Project Name: 9101 Highland

Description: Revised special land use approval and final site plan approval

RE: 9101 Highland Road-Proposed Commercial Development- Final Site Plan/Final Engineering Plan Review – 3rd Review

Final Site Plan / Special Land Use Review for White Lake Charter Township, Michigan

SITE PLAN

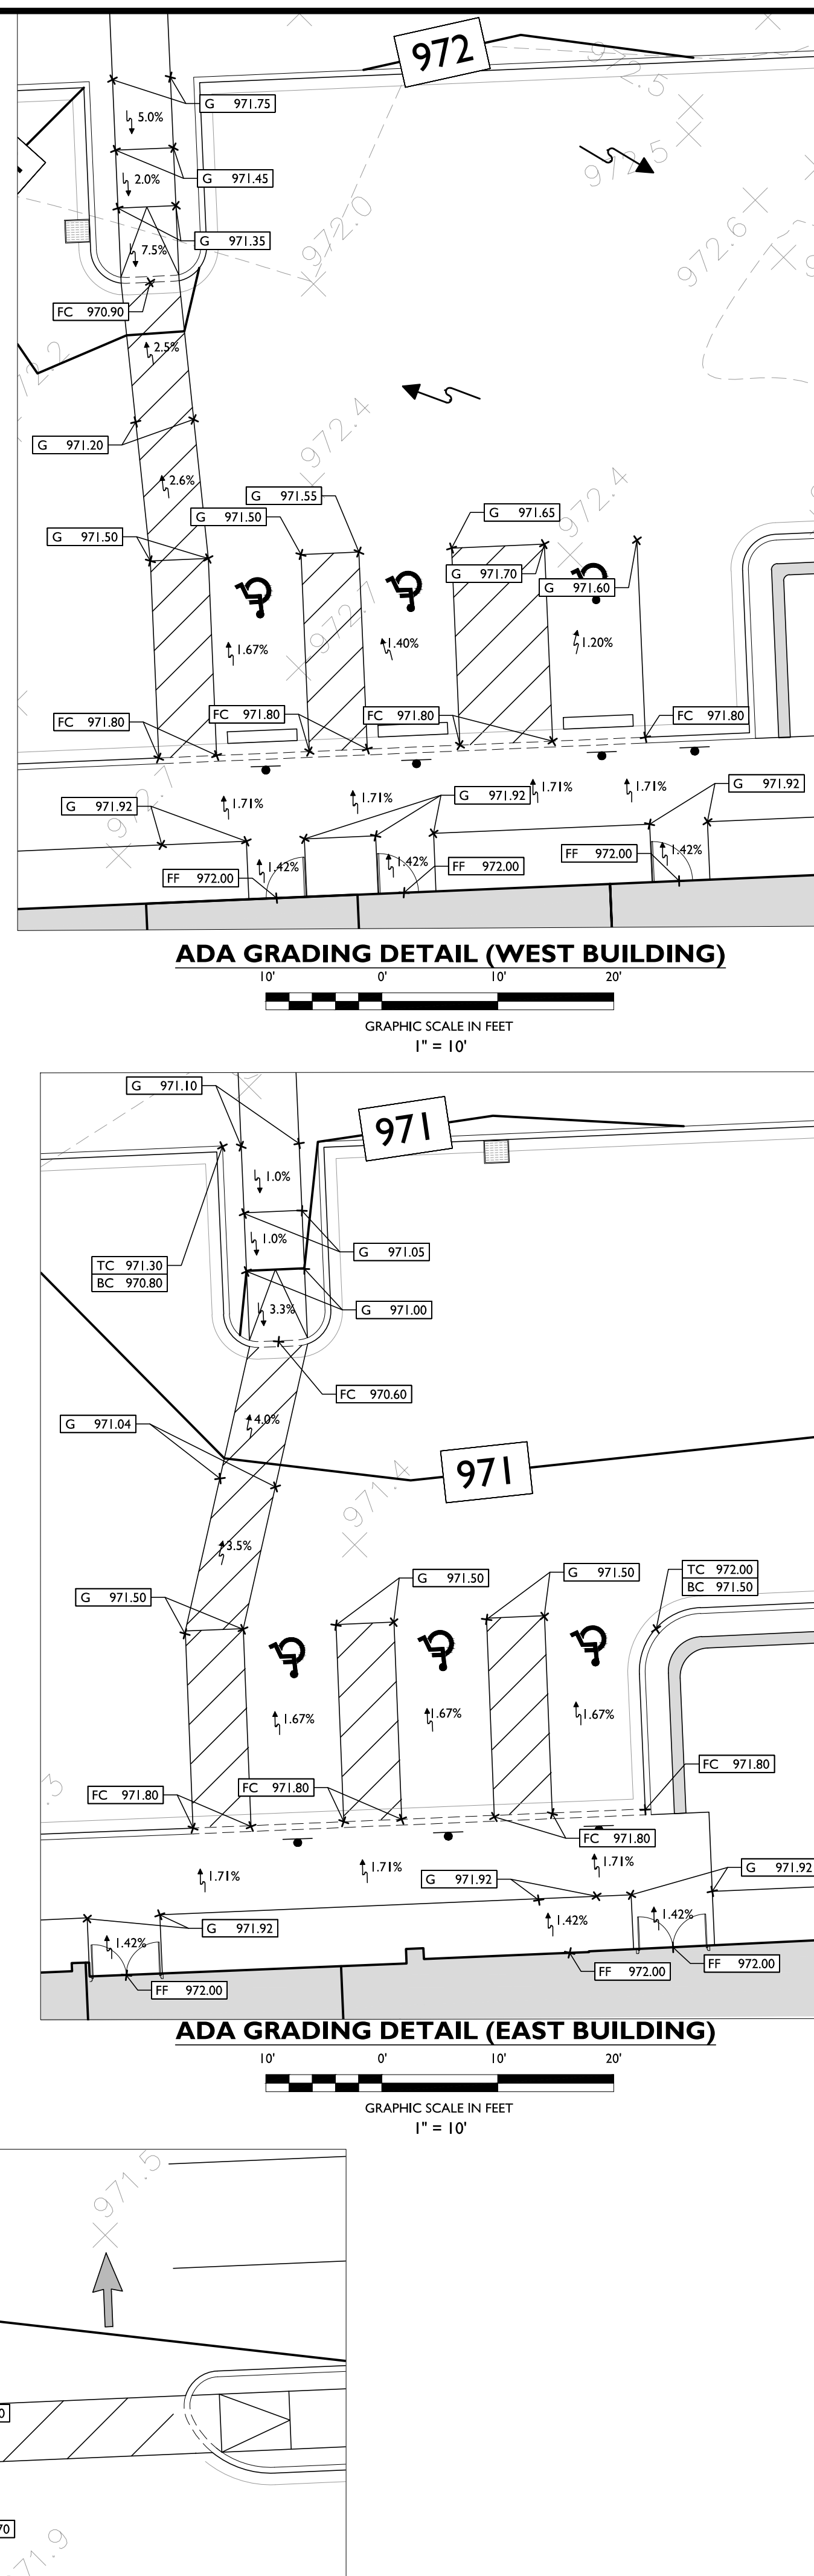
Sheet C-3 shows a proposed stub access drive at the west end of the property. A note indicates the drive is a proposed twenty four (24) foot access drive and easement to be stubbed at the property line. Also included in the final site plan application is an exhibit showing the location and dimensions of the proposed access easement.

Section 5.11 outlines requirements for off-street parking. Sheet C-3 provides parking locations and calculations for the various retail and restaurant functions anticipated for the site. Parking is placed predominantly around the periphery of the two buildings with a limited number of spaces located between the structures. Parking lot and drive aisles will be constructed of asphalt. Concrete is proposed for limited portions of the drive thru and dumpster pads.

Parking has been reconfigured to allow for larger proposed patio areas in front of both buildings. One additional mobile order pickup space has been added and one standard space has been removed since preliminary approval. The site layout indicates one hundred twenty one (121) spaces are provided. The Off-Street Parking Requirements table on Sheet C-3, as well as the landscape plan on Sheet C-10, state one hundred nineteen (119) parking spaces are provided. The math computing the total required parking in the "Off-Street Parking Requirements" table states one hundred forty six (146) spaces are required. These errors do not affect compliance with parking requirements, however the correct amount of provided parking should be reflected in all calculations and site layouts.

Sheet C-3 shows a six (6) foot high vinyl fence around the detention basin. Per landscaping buffer requirements between specific zones, an eight (8) foot obscuring fence is proposed parallel to the eastern and southern lot lines where the property abuts residential districts. The fence is located 20 feet in from the site's property line. Sheet A-302 shows the fence will be an eight (8) foot tall white vinyl fence.

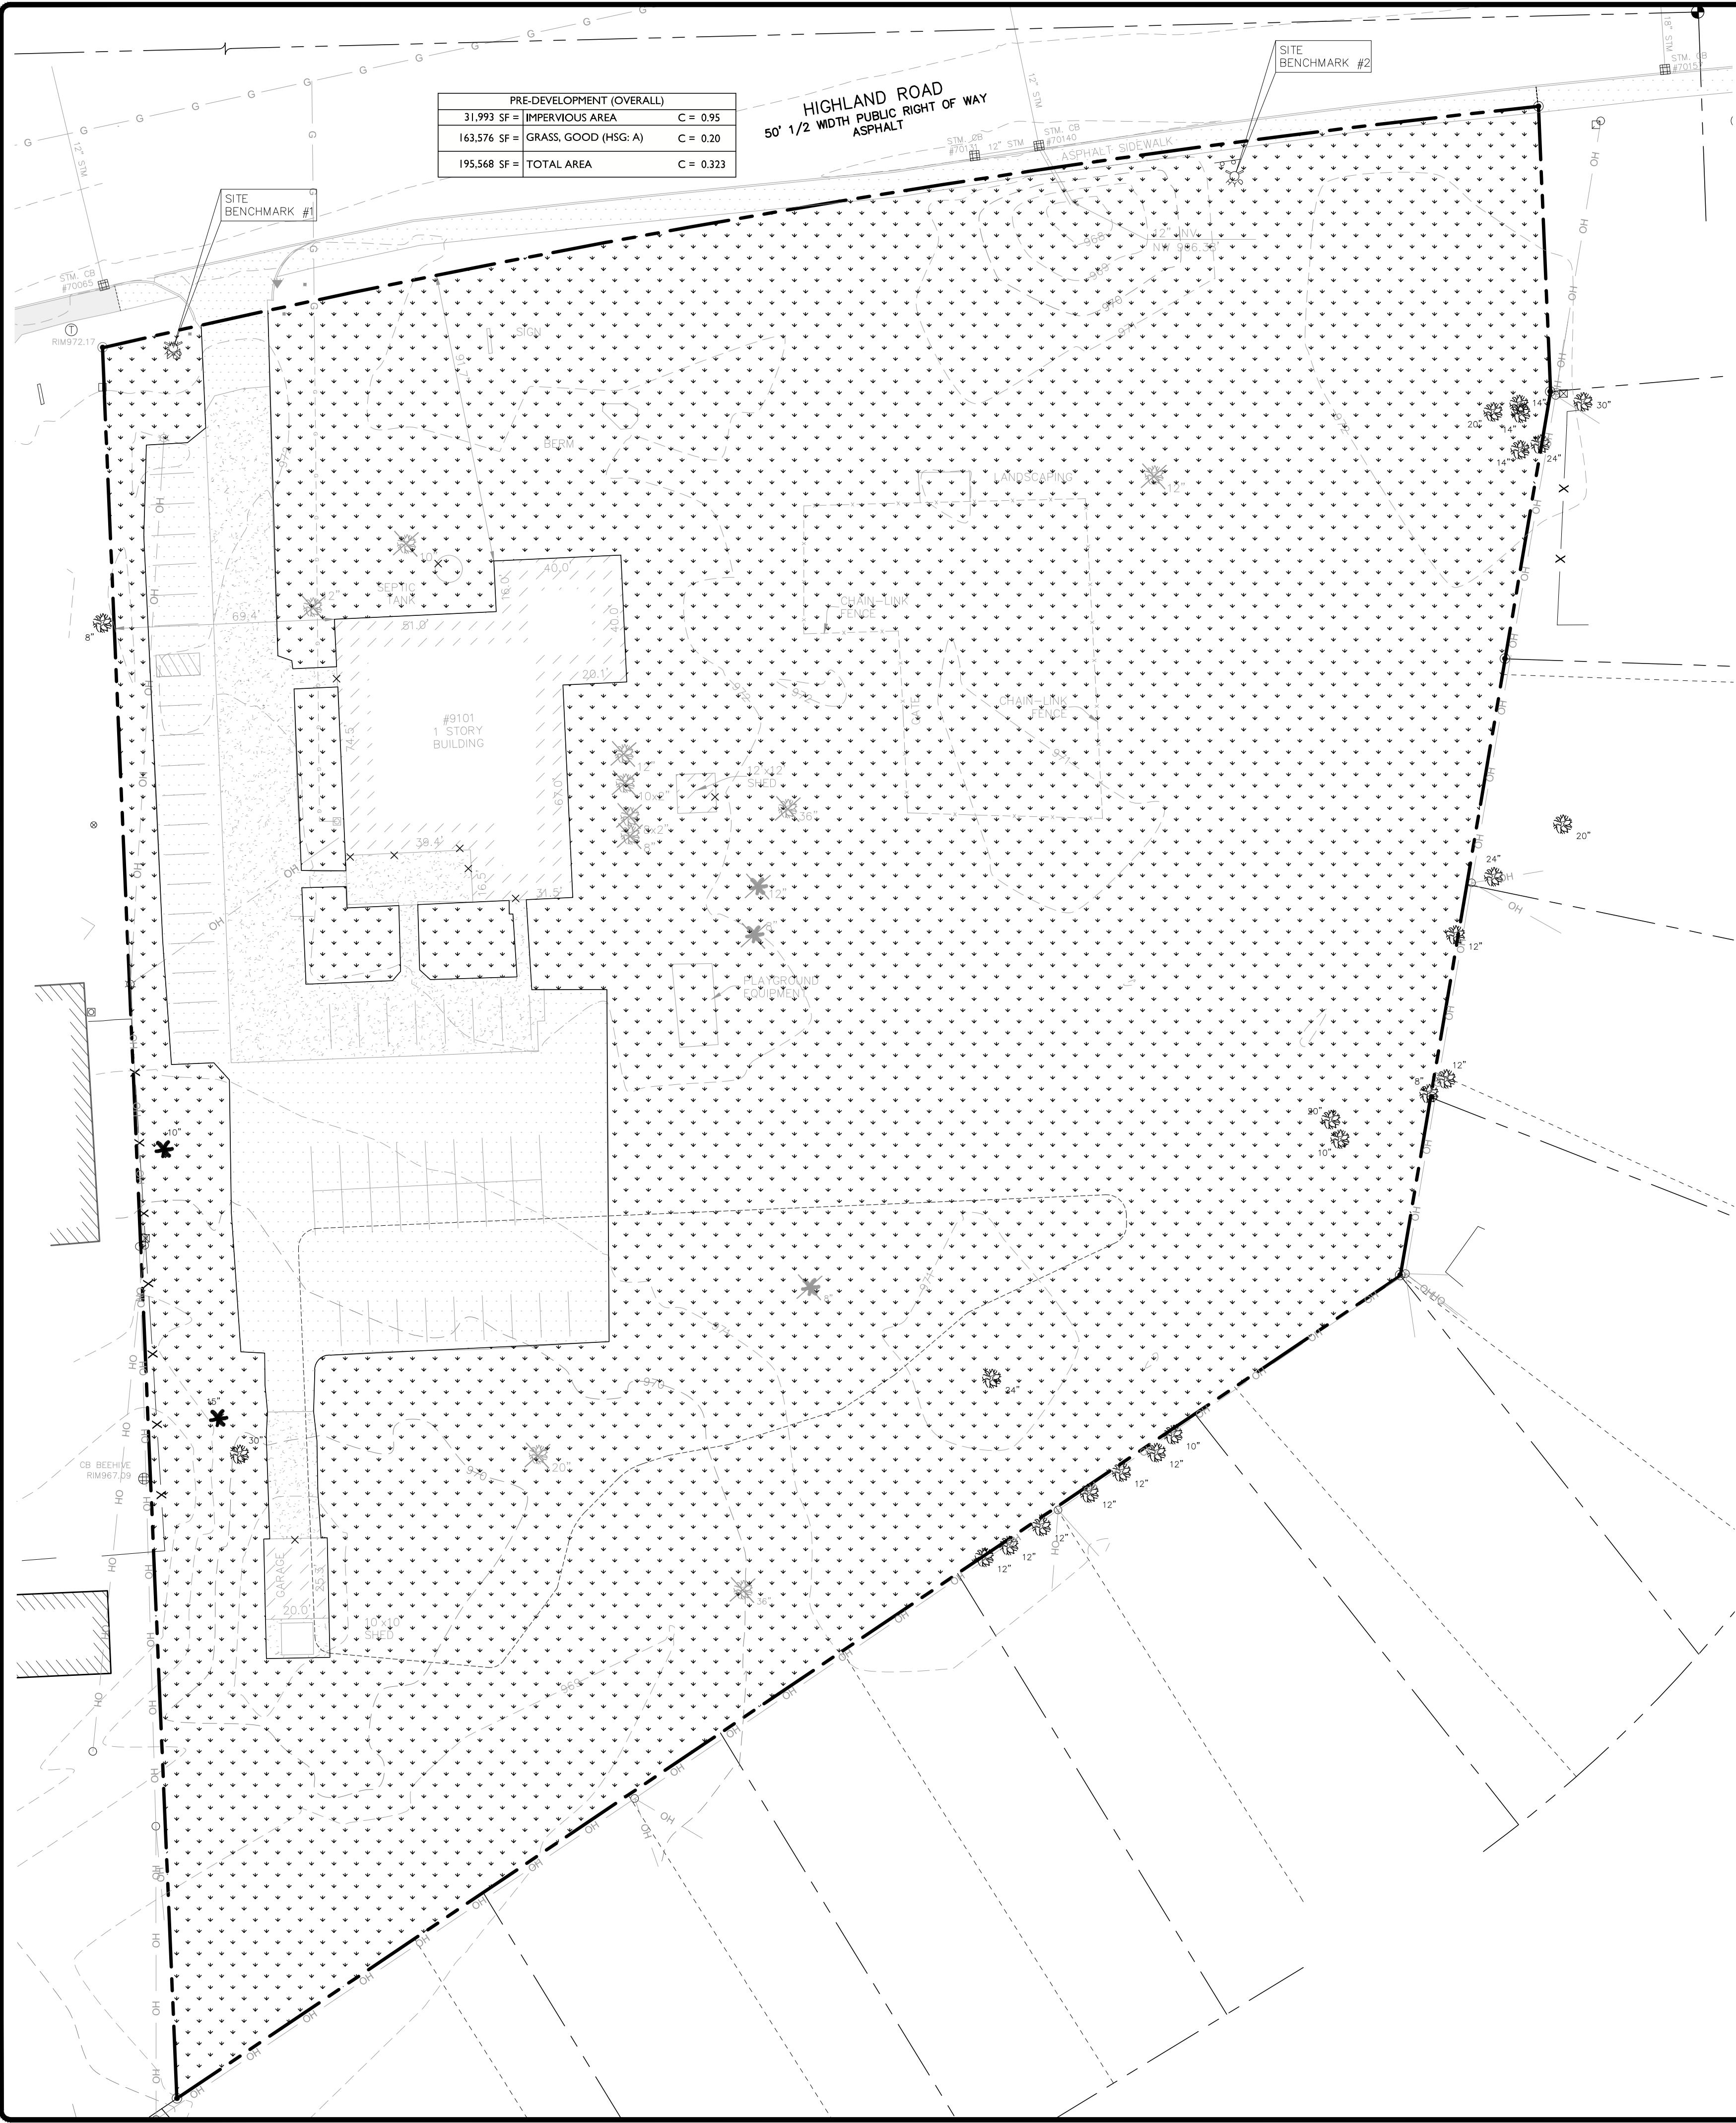
2. *Sheet C-4-Please reference red lined plan sheet for a few concerns. Comment partially addressed. The majority of comments have been addressed; however, there are additional items on the grading plan sheet (due to the addition of ADA grading details) that shall require revision. The marked up grading plan red-lined sheet has been attached for the design engineer's use.* **Comment partially addressed. The rim elevation of 970.85 for storm structure D-201 does not match the rim elevation of 970.90 on Sheets C-8 and C-19.**

Topography: Sheet C-4 show existing site topography as well as the proposed grading. With the exception of a natural depression along Highland Road (M-59) on the east side of the site, the lot is predominantly flat. Minor grading will be required to support proposed structures and site improvements with more extensive excavation required for the proposed detention pond south of the development.
